Change Number M-16-01-01	Federal Facility Agreement and Consent Order Change Control Form Do not use blue ink. Type or print using black ink.	Date 1/4/01
-----------------------------	--	----------------

Change Title
 Establish Interim Remedial Action Milestones for the 100-IU-6 Operable Unit (OU) 0054423

Figure 1: JA Jones and 600-1 Site Boundary

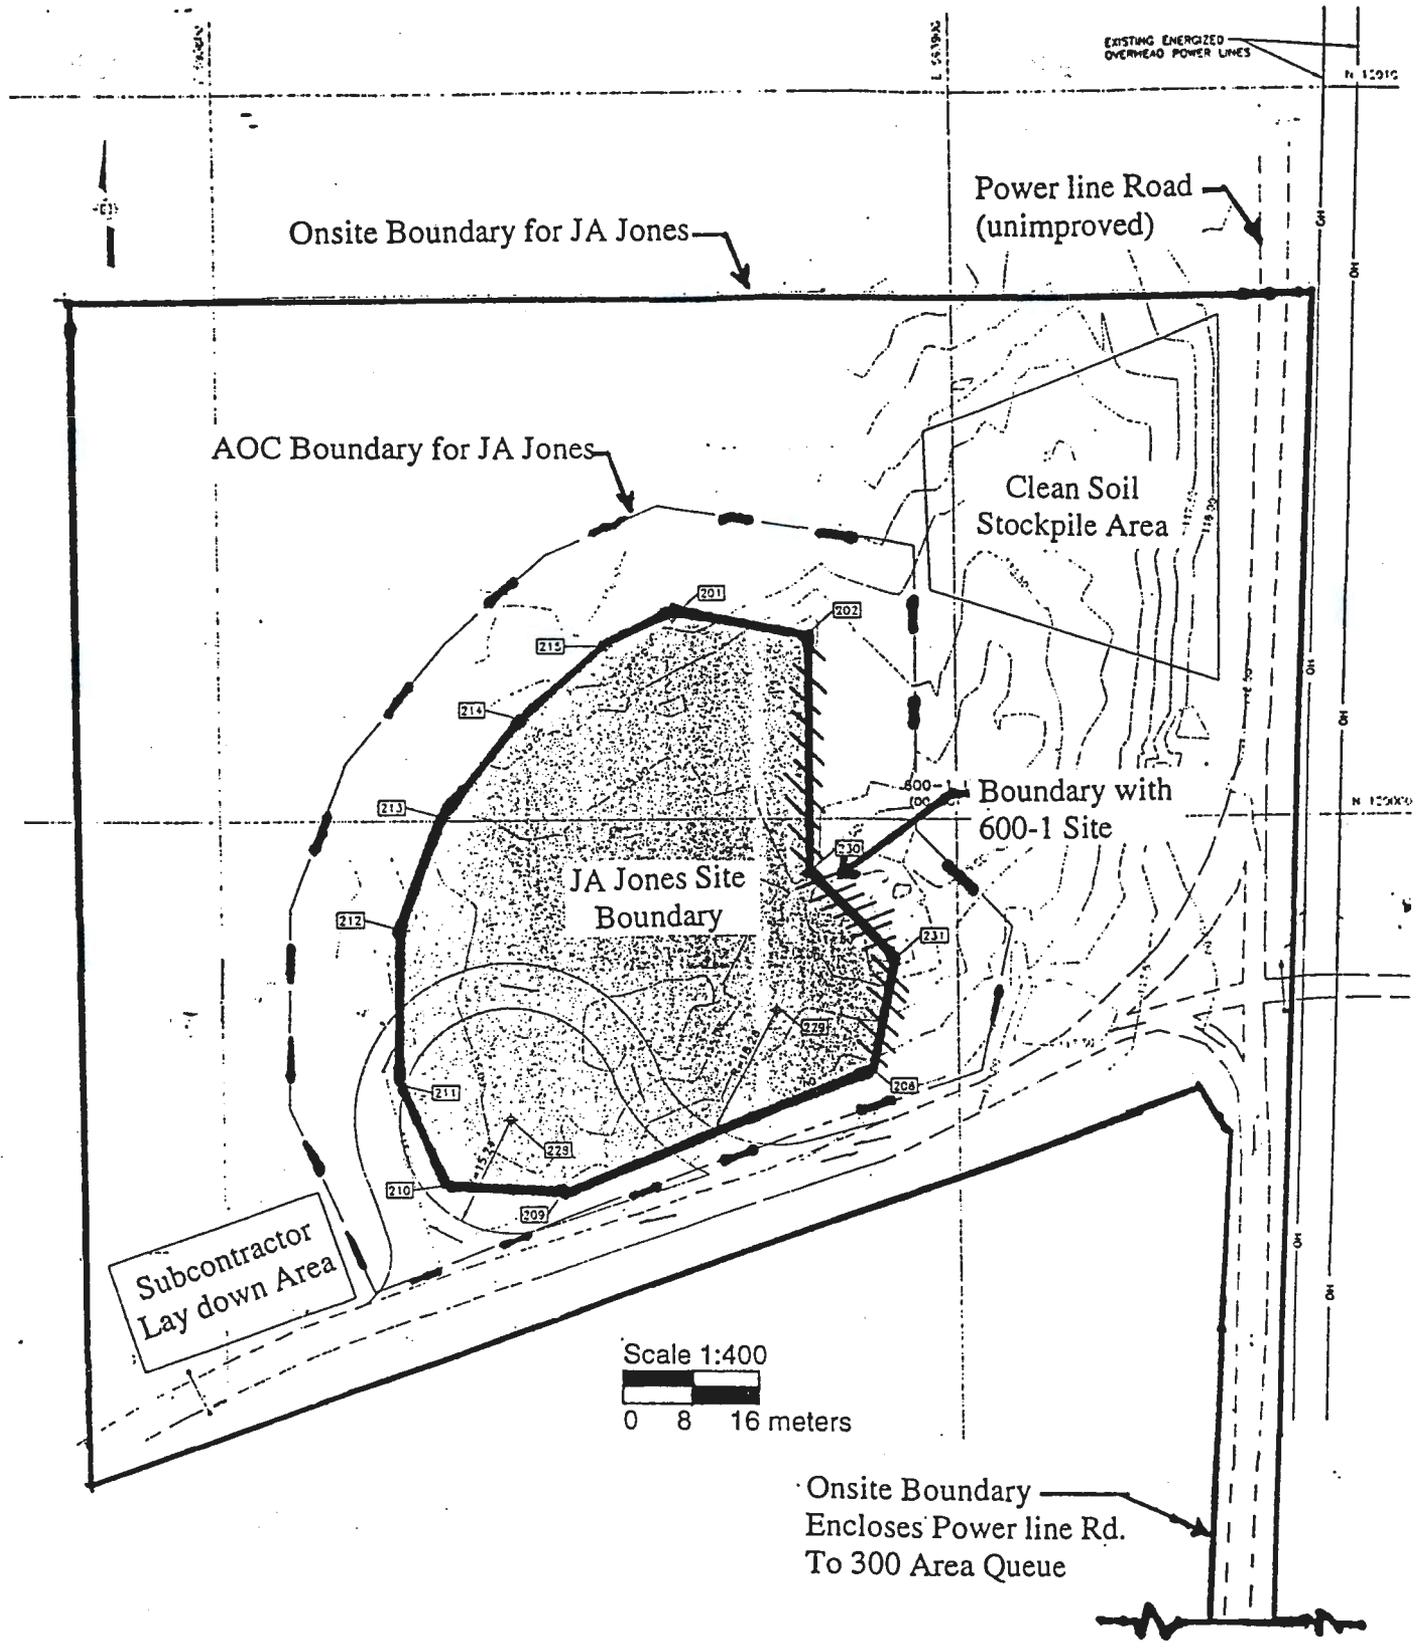
- The physical boundary between the JA Jones 1 site (to be excavated) and the 600-1 waste site (no action) is depicted in attached Figure 1 as can best be determined from WIDS descriptions and interpretation of surface geophysical data. Excavation beyond this boundary is considered a plume.
